The City of Saint John

**Date:** December 10, 2021  
**To:** Planning Advisory Committee  
**From:** Growth & Community Services  
**Meeting:** December 14, 2021

# Design Review of the Fundy Quay Development Masterplan

# Design Review Summary

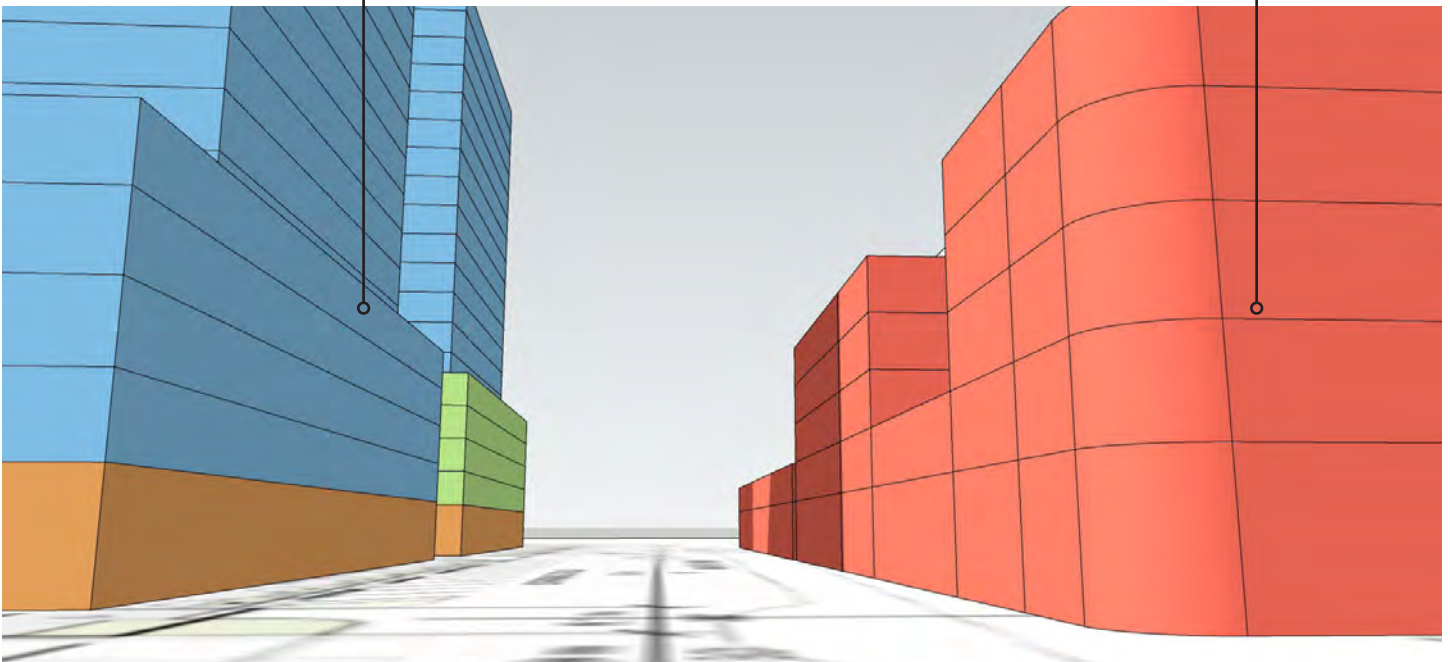
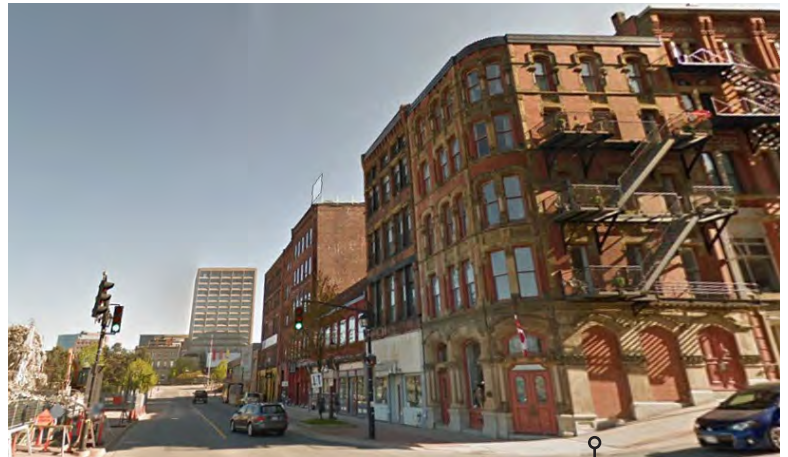
The masterplan proposes a variance from current by-laws, to increase the allowable height of the podium facades along Water Street. The intention is to match the existing (east side) Water Street facades.

The proposed street wall of the podium along Water Street is in keeping with the context. However, if additional floor to floor height be requested, it is recommended that the total podium height match the existing East side of Water Street of 25m, +/- 1m. It is more important that the overall street wall height the same, rather than the number of storeys.

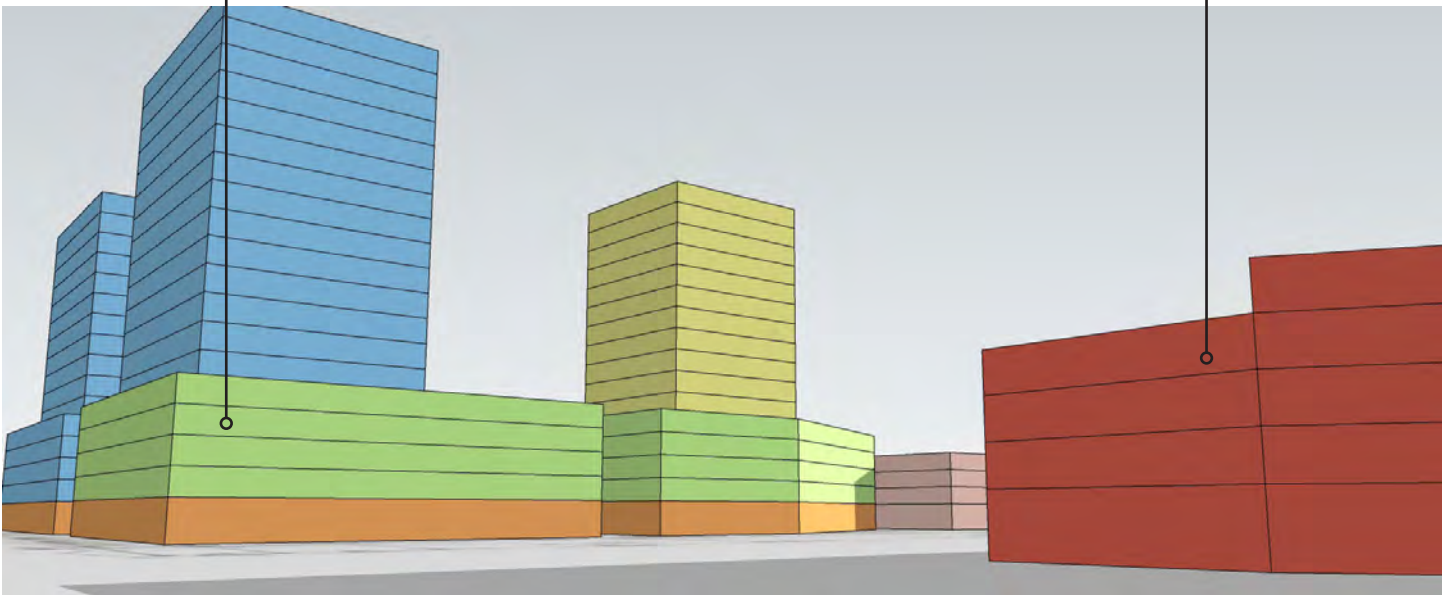
The street wall next to North Market Wharf- 5 storey: is in keeping with the context of the existing built form. Though North Market Street buildings are a floor lower than the proposed masterplan buildings from phase 3, 4, and 5, the distance is far enough away that they will feel similar enough. The 3 new buildings will create a new street wall, resulting in a comfortable sense of enclosure around the new park. In addition, activating the ground floor will provide a positive pedestrian experience support the retail and hospitality businesses.

## Wind Study:

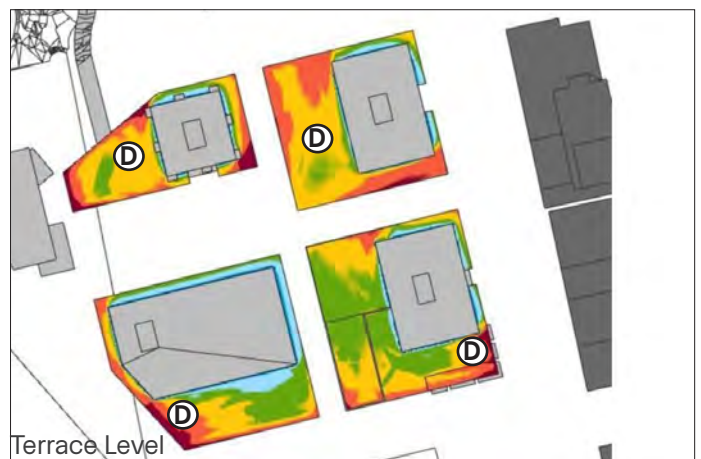
The wind study provided by RWDI does indicate a few problem areas that have uncomfortable wind speed as a result of the proposed design.

(A) Channeling generated by the new street wall along Water Street will increase the average wind speed at street level. While this is not necessarily problematic, on average it is however likely to increase the number of uncomfortable days for pedestrians sitting on street side patios. Additional trees and landscaping conducive to reducing wind speed should be implemented here.

(B) Channeling winds at the South East retail/commercial entrances for Phase 1 will be uncomfortable, on average, for pedestrians. The high winds are not largely a result of down drafts so the canopies shown in the design will not significantly reduce wind speed. However, recessed entries and other vertical obstructions would be advisable. Further testing following design resolution will be needed to validate and prove the design is reducing wind speeds to a comfortable norm.

(D) The close proximity of the towers to one another generates a severe down draft onto the podium terraces, which will not create the desired design intention of these spaces. As written by Lydon Lynch as design rationale for the terraces: *"Atop the podium rooftops, each building will provide its residents with high quality indoor and outdoor amenity spaces. A portion of the roofs will be*

*green roofs in order to provide residents with green space, leisure activities..."* Additional canopies are likely the only potential solution to reduce wind speed, but likely not to the degree of comfort, as required for the program intended. Further design iteration and testing is required.

## Shadow Study:

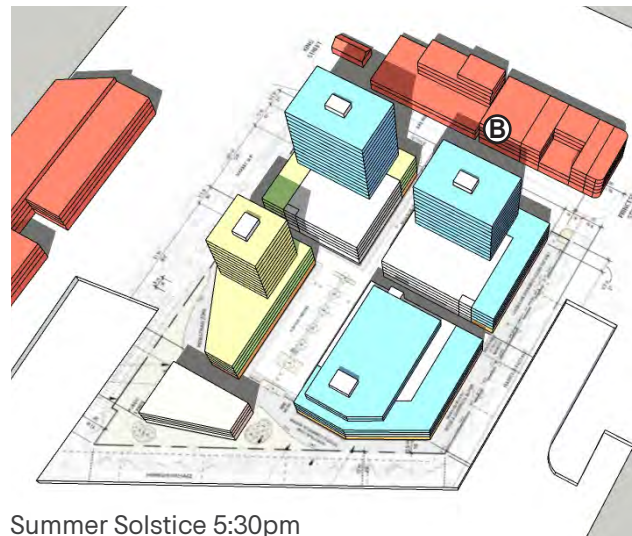
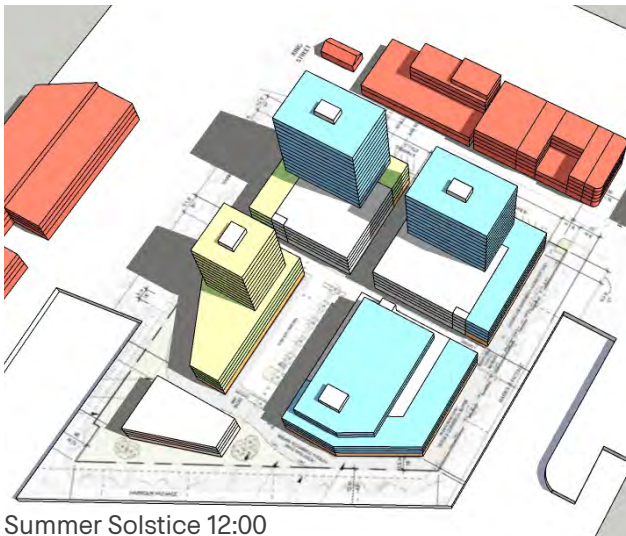
The towers located on the northern edge of the site provide minimal shadow throughout the day onto the internal courtyard space, but create extensive shadows over the public park to the north.

would cast a full shadow over the courtyard in the winter anyway. Therefore, building the tower there instead would not change the sun loss in the area dramatically over the winter, but would allow more sun for the public park.

(B) Shadows will be cast over Water Street. The existing buildings and ground floor uses will be impacted by both an increase in shadow through the later afternoon and increased wind speeds, as mentioned in the Wind Study.

## Pedestrian Experience:

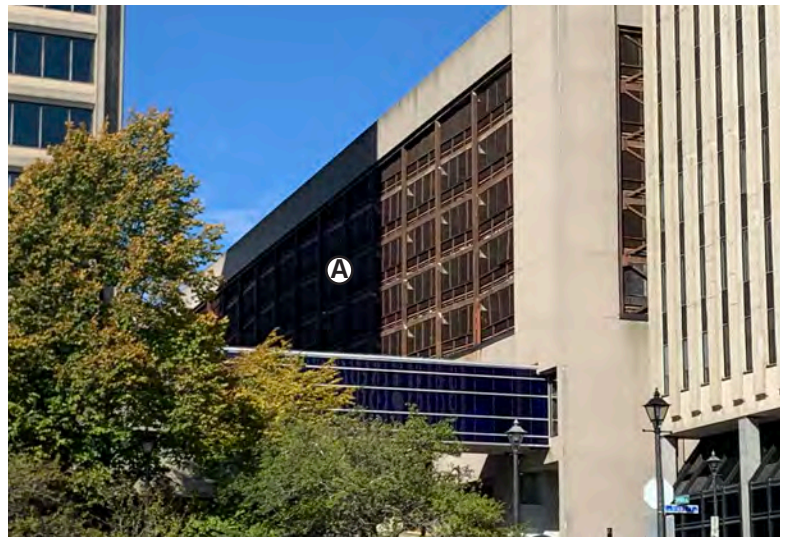
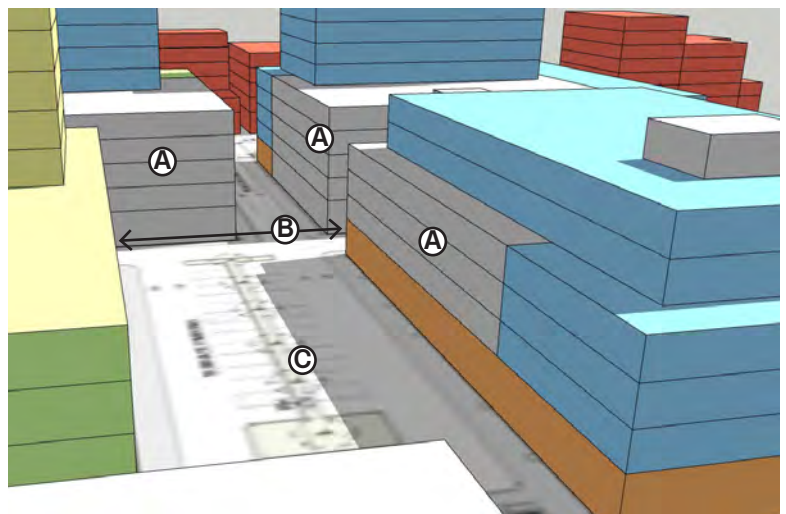
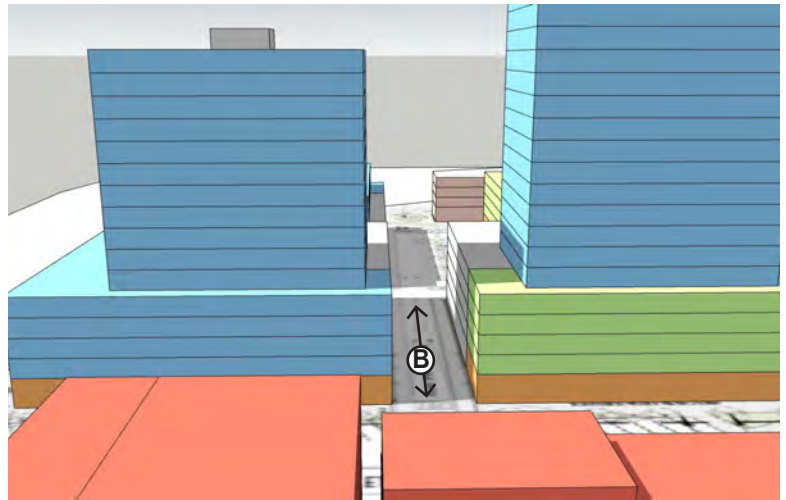
The interior courtyard is largely surrounded by parking garage structures. (A) The resulting pedestrian experience of the interior courtyard (C) will not be positive or create a feeling of safety in the evenings.

## Pedestrian Experience:

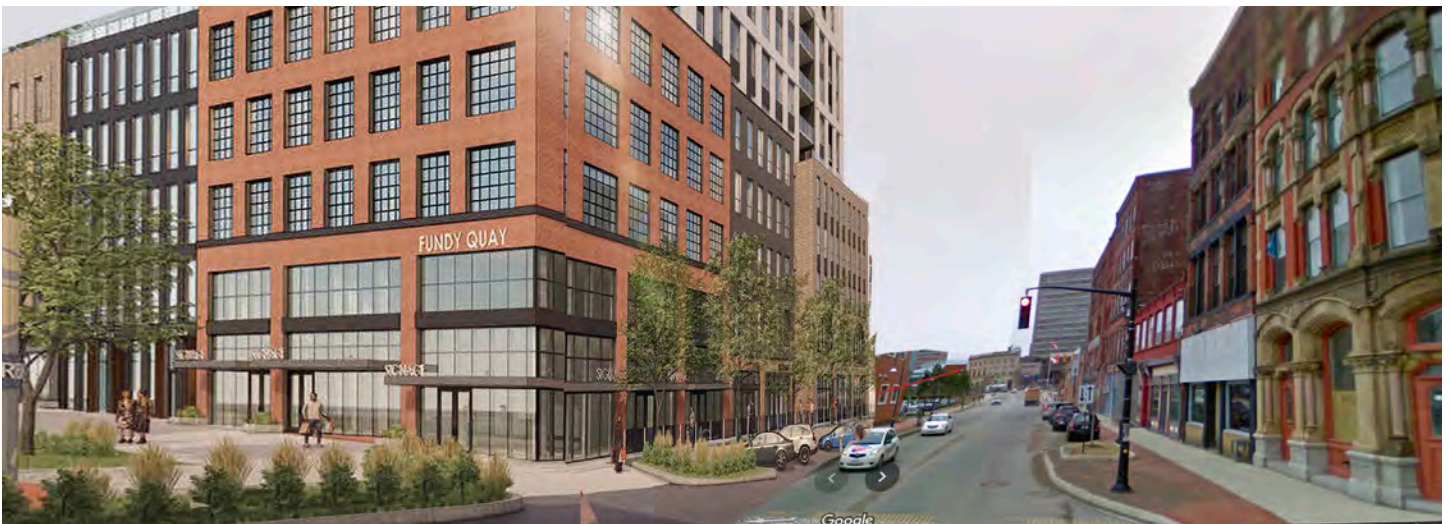
The Water Street pedestrian experience will be improved greatly with the addition of the proposed buildings, in essence completing the street with retail and commercial functions on the ground floor.
